**ADDENDUM
NO. 1**

March 3, 2021

Scott County School District 1 – Austin Elementary Additions & Renovations and HS Pool Renovation
Austin, IN 47102

ADDENDUM NO. ONE

A201

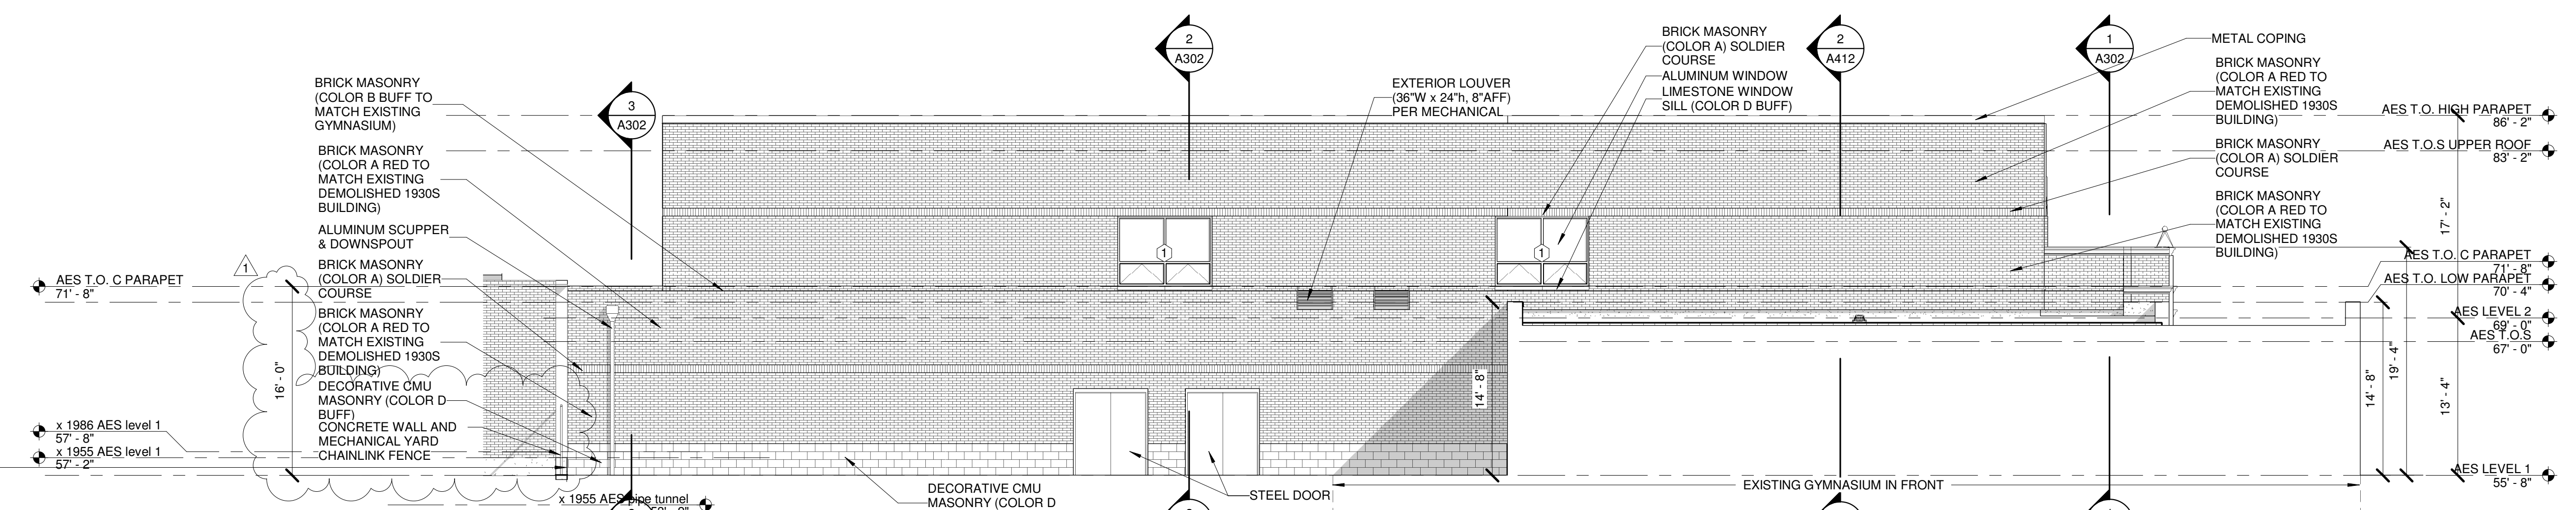
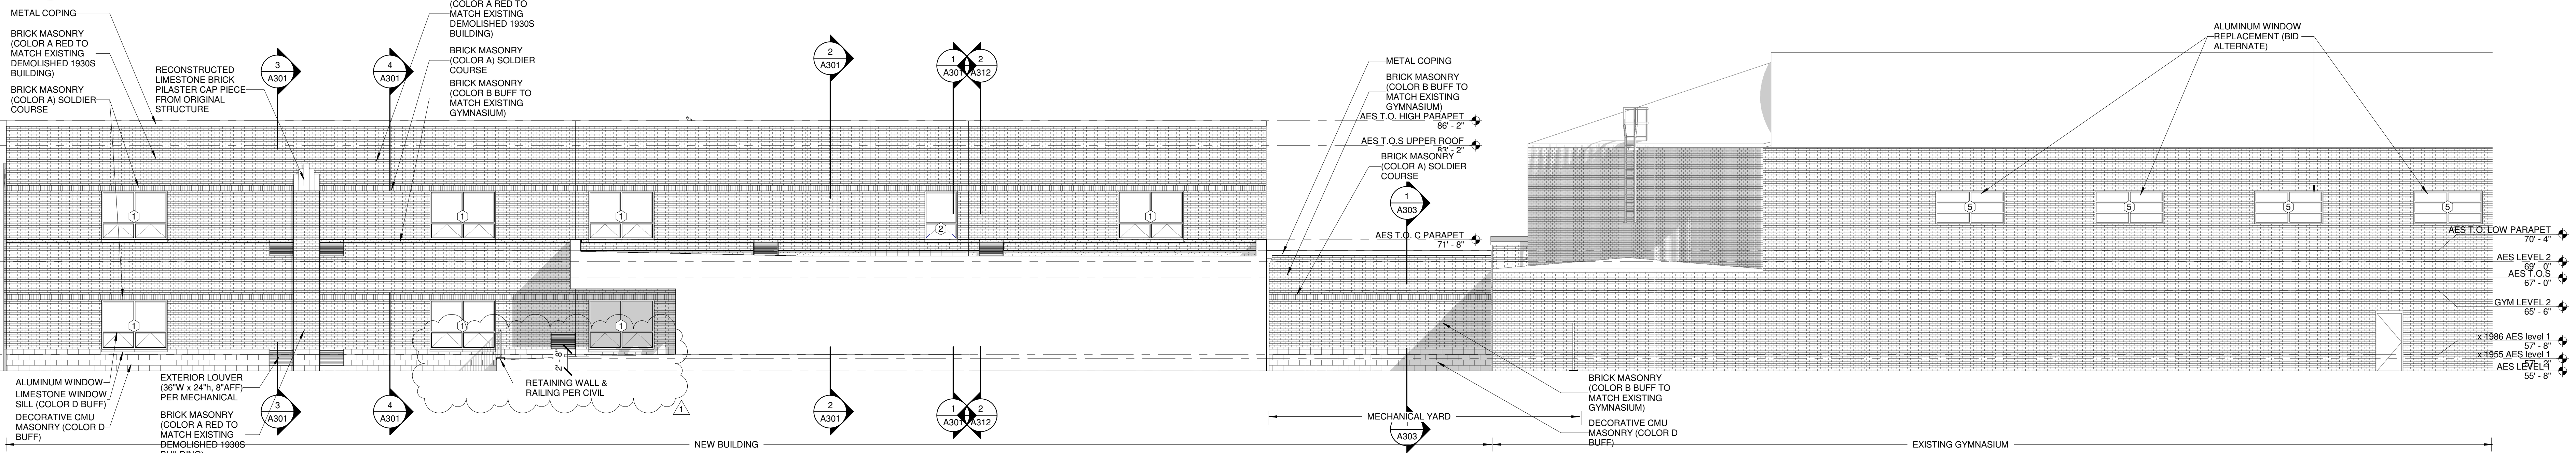
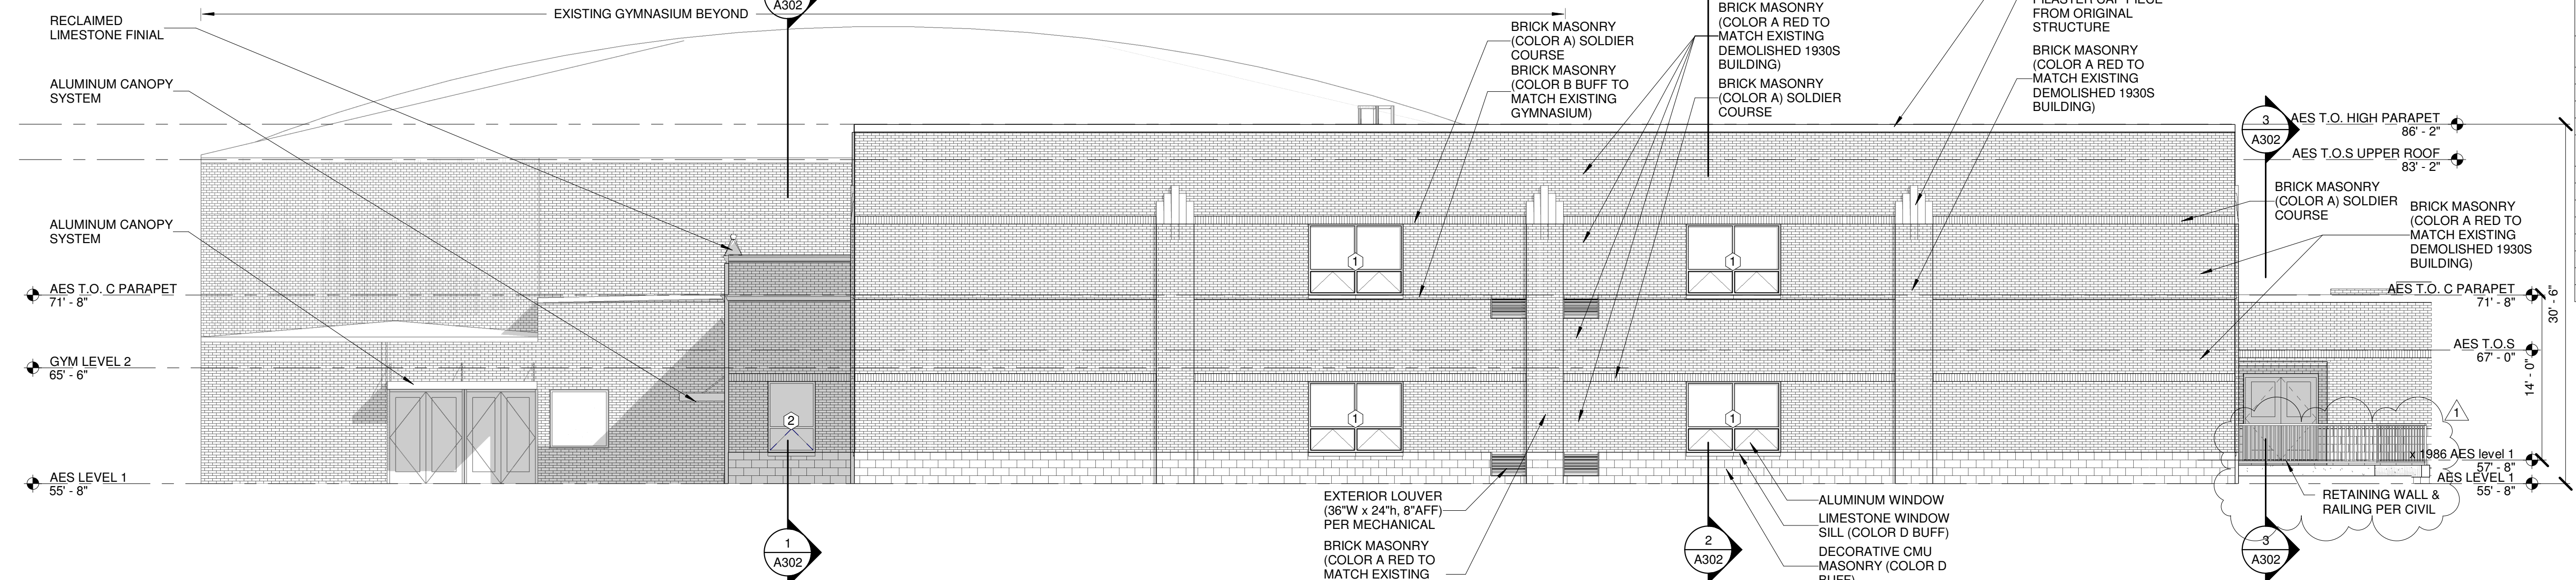
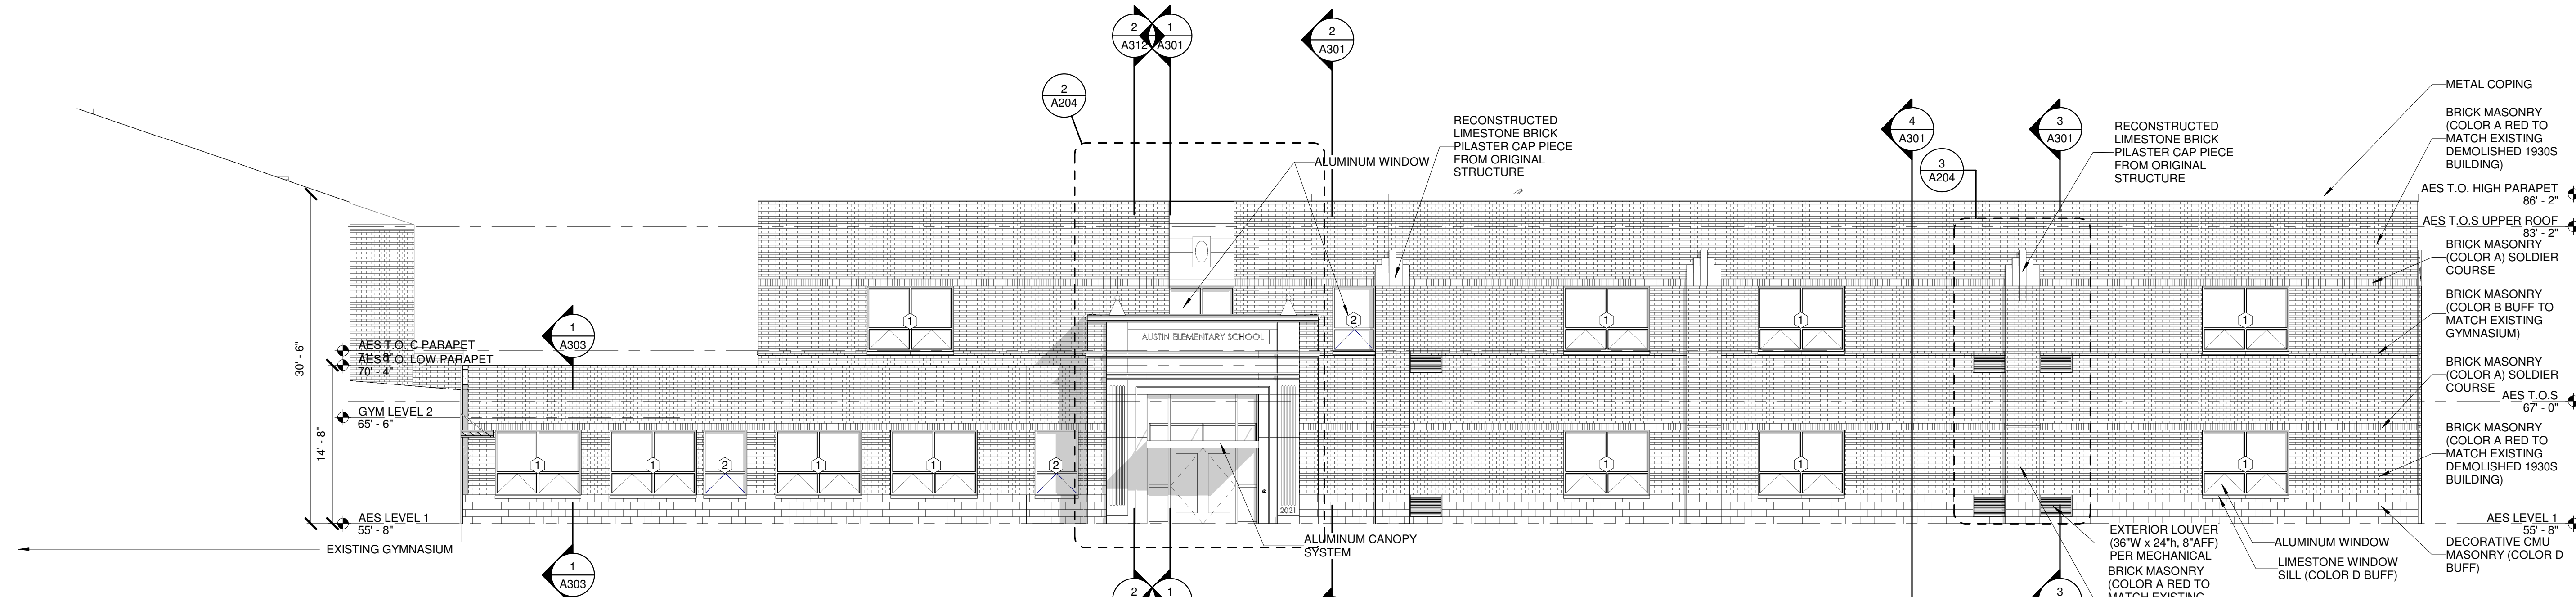
6. Drawing No.: A201
Drawing Sheet Title: EXTERIOR ELEVATIONS - AES
Revision:
Clarified retaining wall, railing and fence discrepancies with civil drawings. See revised sheet attached.
